NATIONAL DAM INSPECTION PROGRAM. STORAGE DAM (NDI I.D. NUMBER P--ETC(U)

⑥ National Dam Inspection Program. **STORAGE DAM**
(NDI I.D. NO: PA-388 → Number
← Number DER I.D. NO: 24-47), Ohio River Basin,
Whetstone Branch of Little Toby
Creek, Elk County, Pennsylvania.
PHASE I INSPECTION REPORT,
NATIONAL DAM INSPECTION PROGRAM

PHASE I REPORT
NATIONAL DAM INSPECTION PROGRAM

NAME OF DAM: Storage Dam
STATE LOCATED: Pennsylvania
COUNTY LOCATED: Elk County
STREAM: Whetstone Branch of Little Toby Creek
SIZE CLASSIFICATION: Small
HAZARD CLASSIFICATION: High
DATE OF INSPECTION: April 6, 1979 and May 25, 1979

PLATE 12

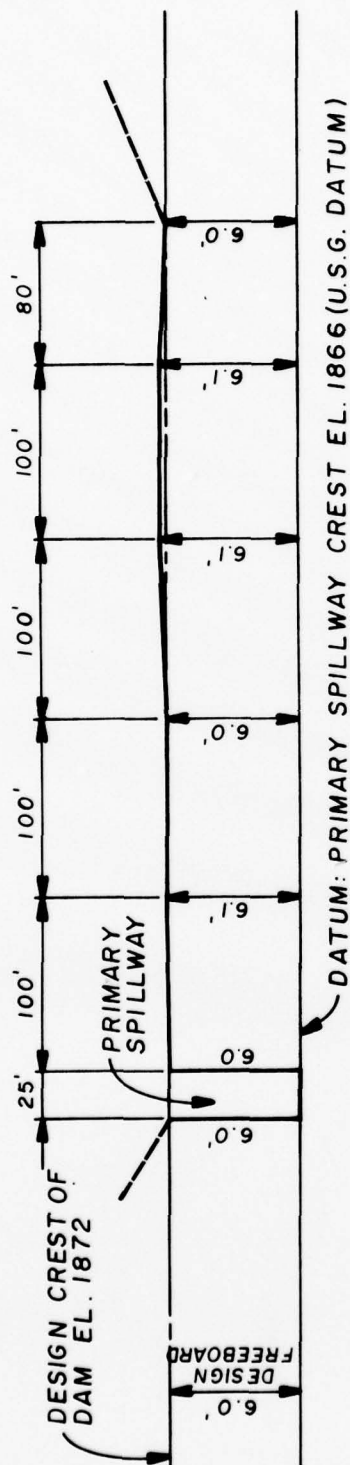
The top of the embankment was surveyed relative to the spillway crest elevation and was found to be in conformance with the design elevation. The crest profile is illustrated on Plate 12.
